AMENDMENT UNDER 37 C.F.R. § 1.116
U.S. Appln. No. 10/663,685
Attorney Docket No.: Q77511

REMARKS

FIG.1

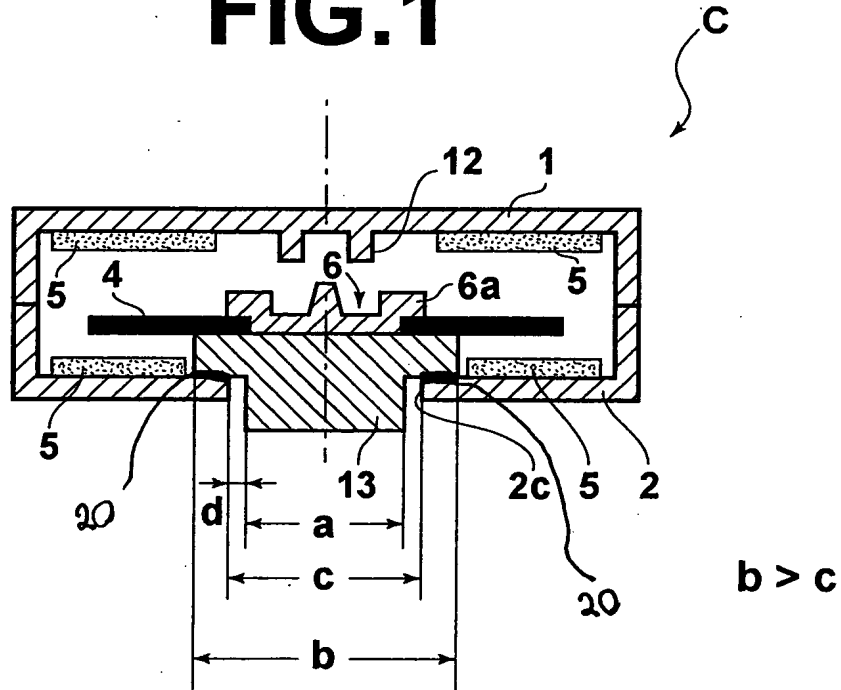
The Examiner, however, issued new objections to the drawings. Specifically, the Examiner requests that the member set forth in claims 13 and 15 be depicted in the Figures. Applicant amends Fig. 1 to illustrate the claimed member. Applicant also amends the specification to describe the newly added element. In view of these amendments, Applicant respectfully requests the Examiner to withdraw this objection to the drawings.

Figure 1 is amended to illustrate an exemplary member with a sliding property.
